UW Work Scope: Bottom CRP Supports Value Engineering Meeting

Feedback/Questions from March Value Engineering Meeting

Module 0 and original FD2 design

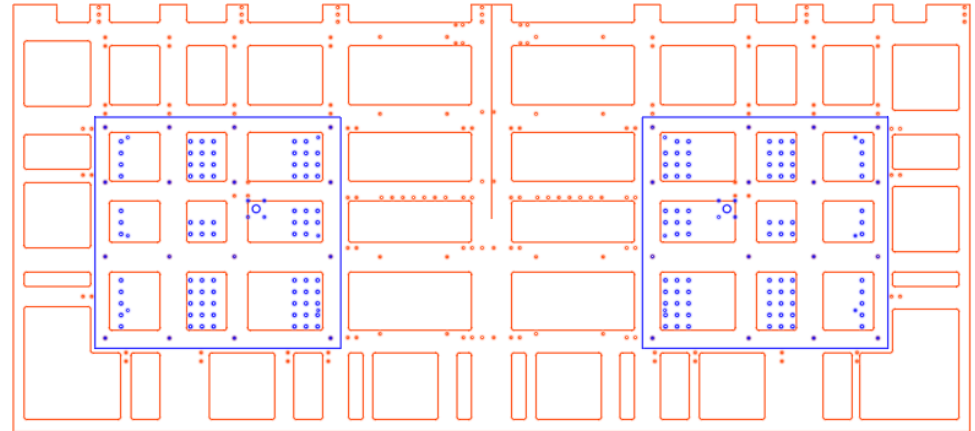
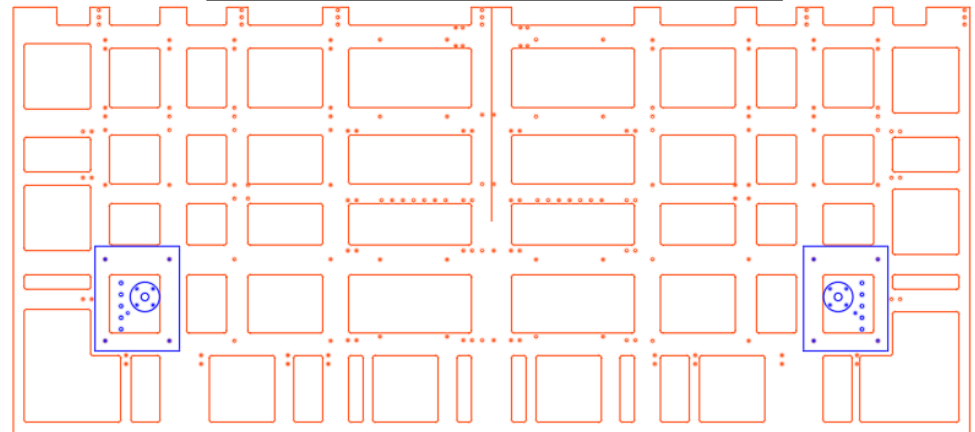
Opportunities for redesign with new CRP 6 structure

Cost savings will have to be balanced against additional design analysis requirement

Larger adapter plates carry all support configurations

Smaller footprint, 11 variations

Module 0 and original FD2 design

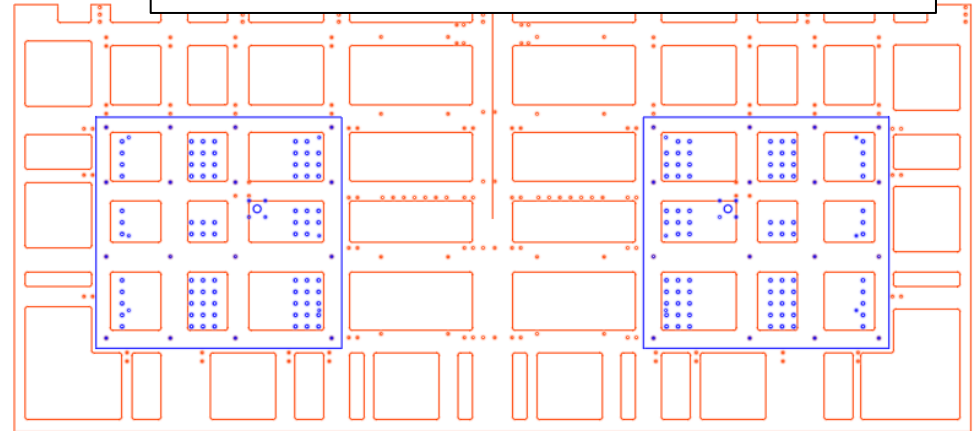
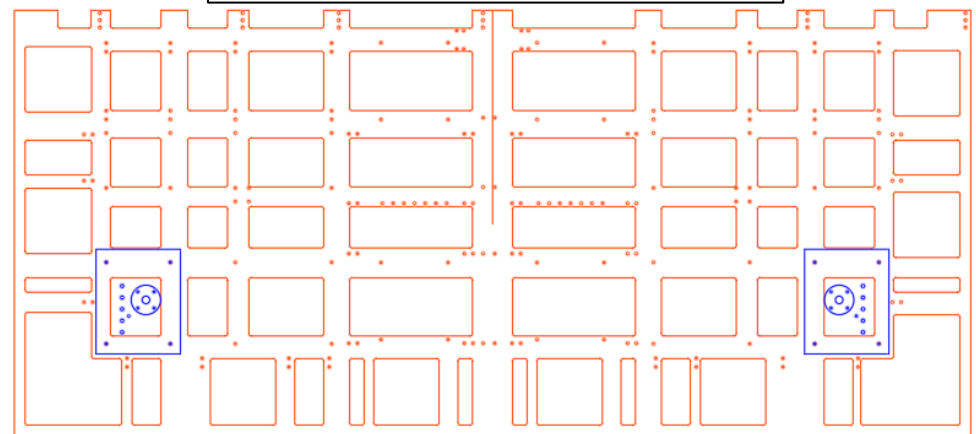
Small Plates require additional design and implementation work

- Would need to **re-run structural analysis**
 - Do small plates **provide enough support** to keep **edge deflections** within tolerance
- Determine if **picking up with tines** would work
 - **Tines** have to **contact CRP** composite structure
 - **Risk in damage** to CRP structure
- CRP factory would need to **reconsider build procedure** and interface with stacker tool

- Has been **verified in structural analysis**
- **Deflection of detector** at edge boards was **within tolerance**
- **Demonstrated with installation tools**
- Tines pick up by contacting the adapter plates. This protected the more fragile CRP composite structure, **no risk to CRP structure**
- **CRP factory** tools have been **designed to interface** with the large plates (stacker tool)
